Application Number **P25-04**

P25-04
Diner 42 Front Addition

Property Owner: IBC Bars LLC
Applicant: William Adams
Location: 665 Lafayette Road
Zoning: I-1 (Industrial)
Request: Transitional Corridor Overlay (TC-OV) District approval for a front addition

365 Lafayette Road Existing Photographs (Prior to Deck Enclosure)

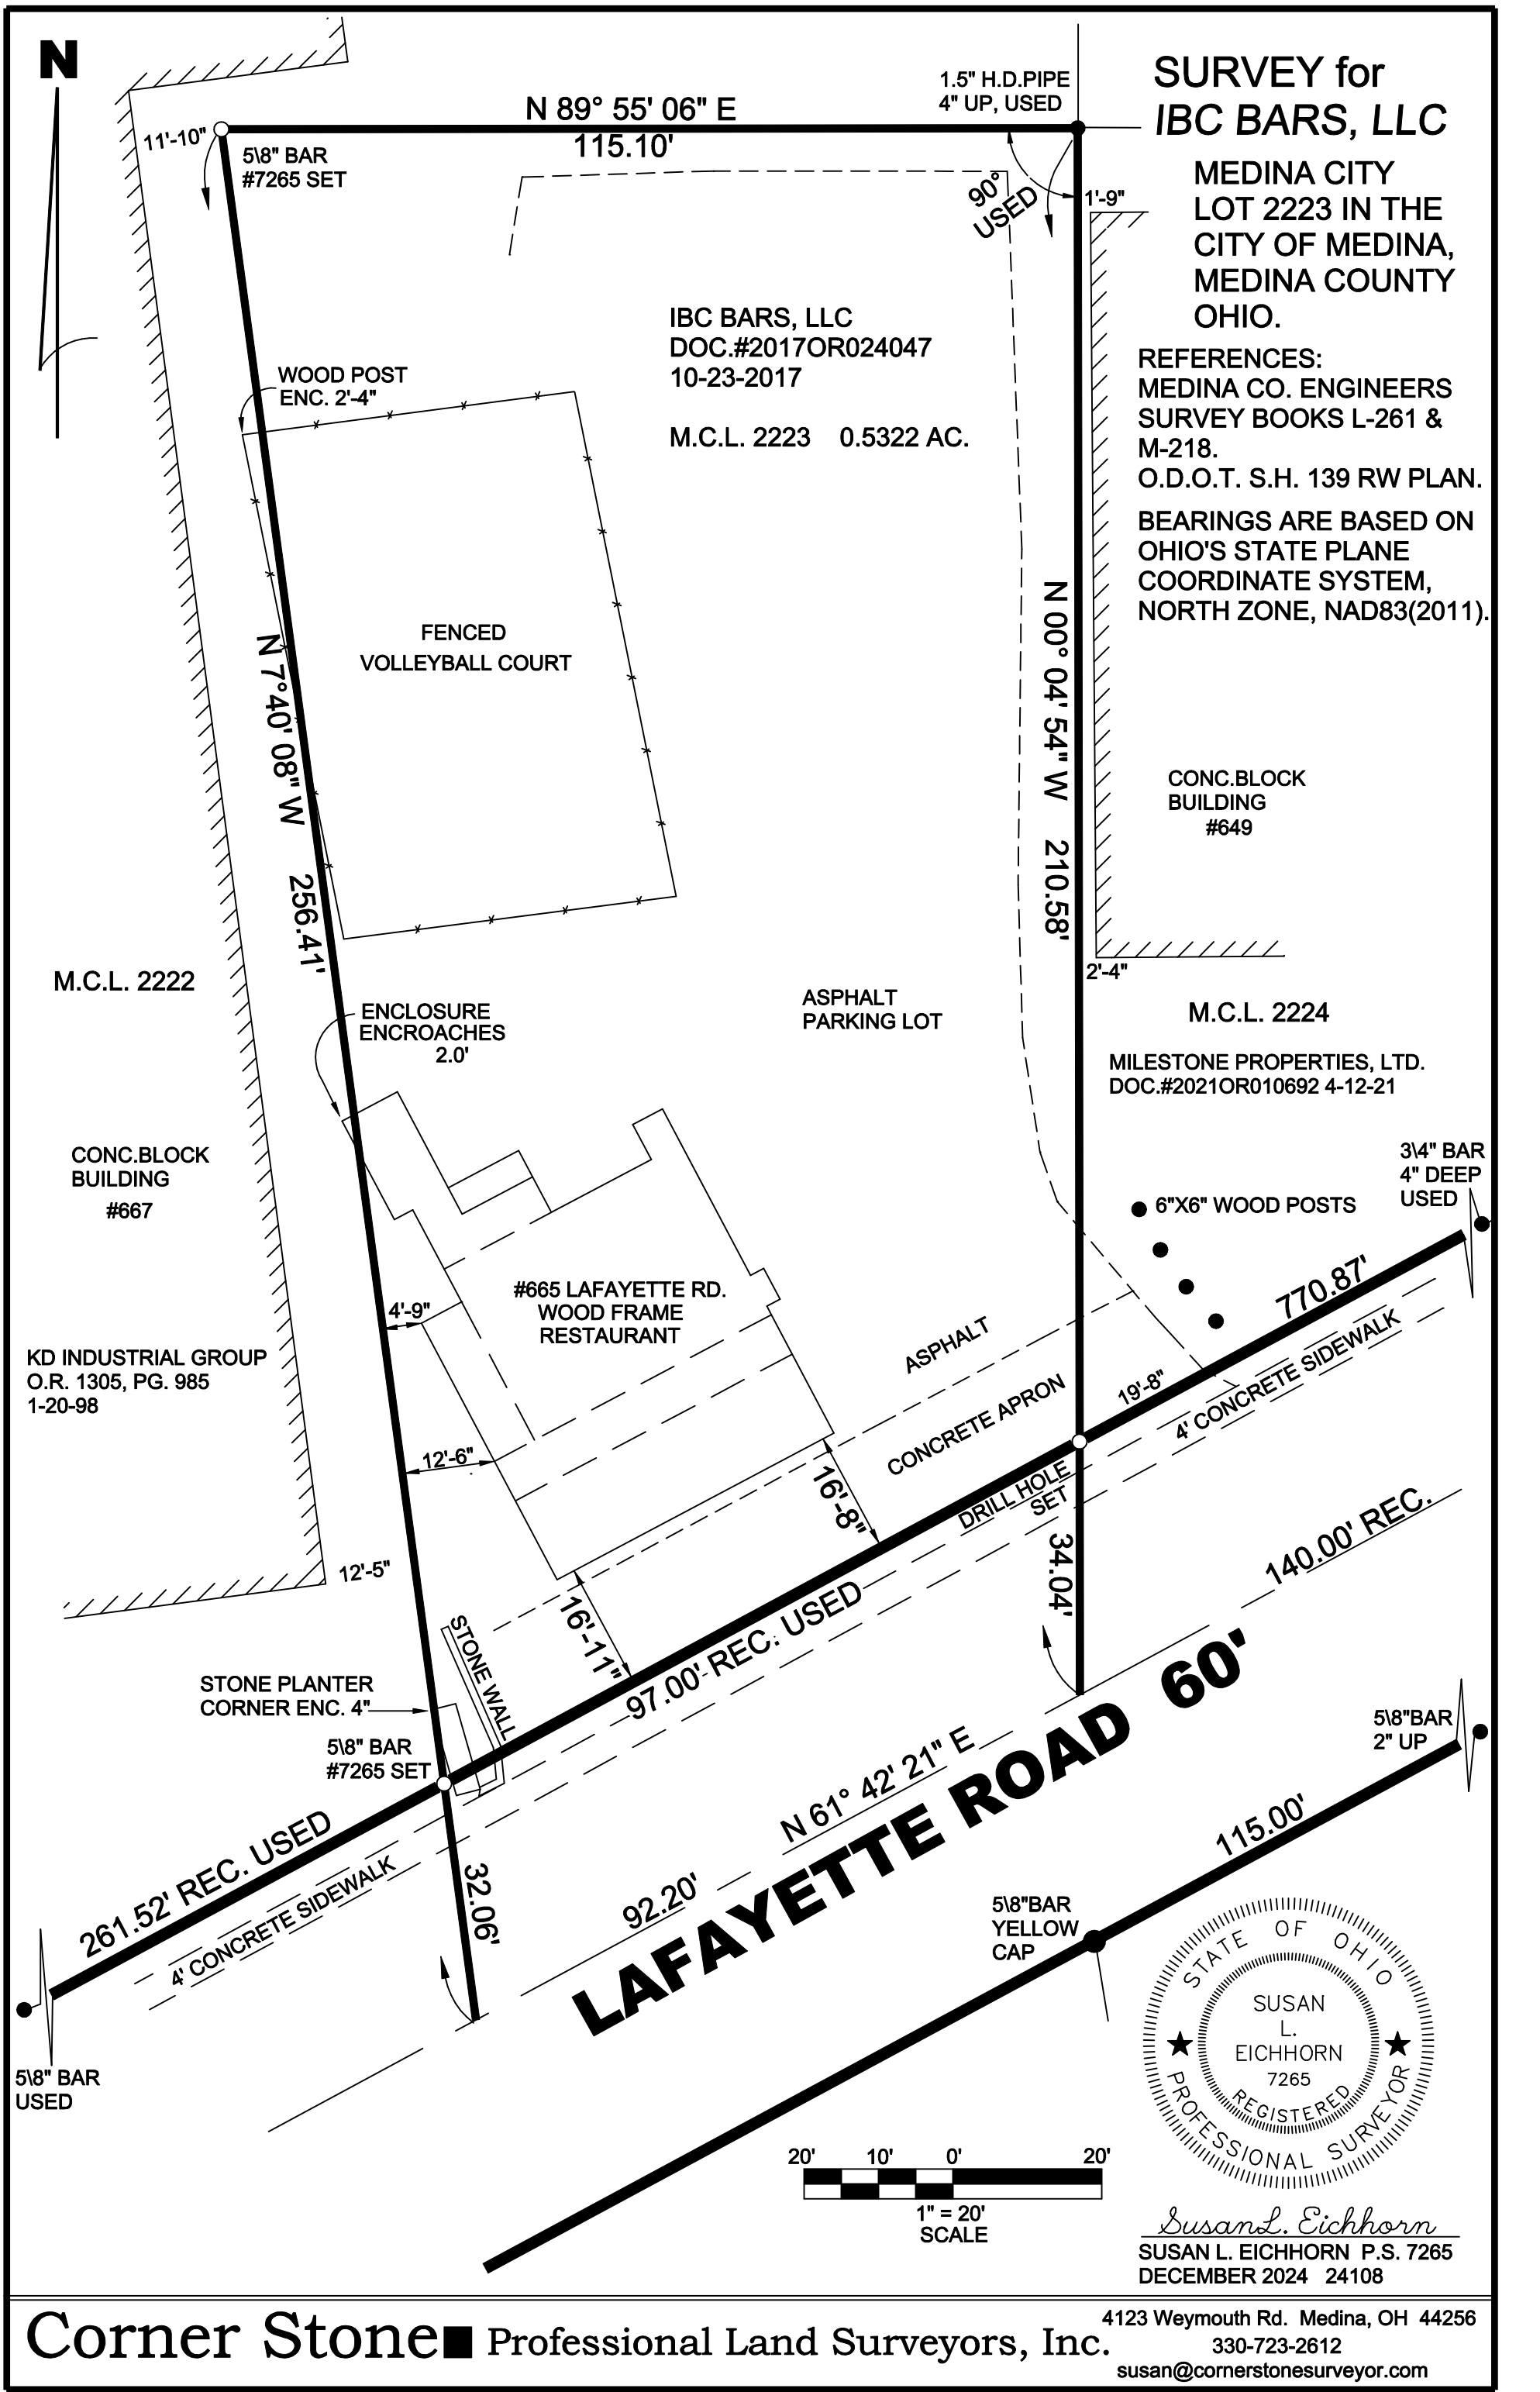
The building previously incorporated an uncovered front deck used for outdoor dining located 16 ft. 10.5 in. from the right-of-way. Recently, the uncovered deck was roofed and enclosed without necessary permits. The enclosure includes a dark metal roof, unfinished wood siding, and windows on all sides.

The incorporation of the enclosure does not significantly alter historic materials or distinctive architectural features. However, the enclosure pushes the front wall of the building beyond the front wall of adjacent buildings.

Staff recommends approval of application P25-04 as submitted with the condition that the project shall comply with Section 1141.05 to allow a principal structure in the front setback or receive variance approval from the Board of Zoning Appeals.
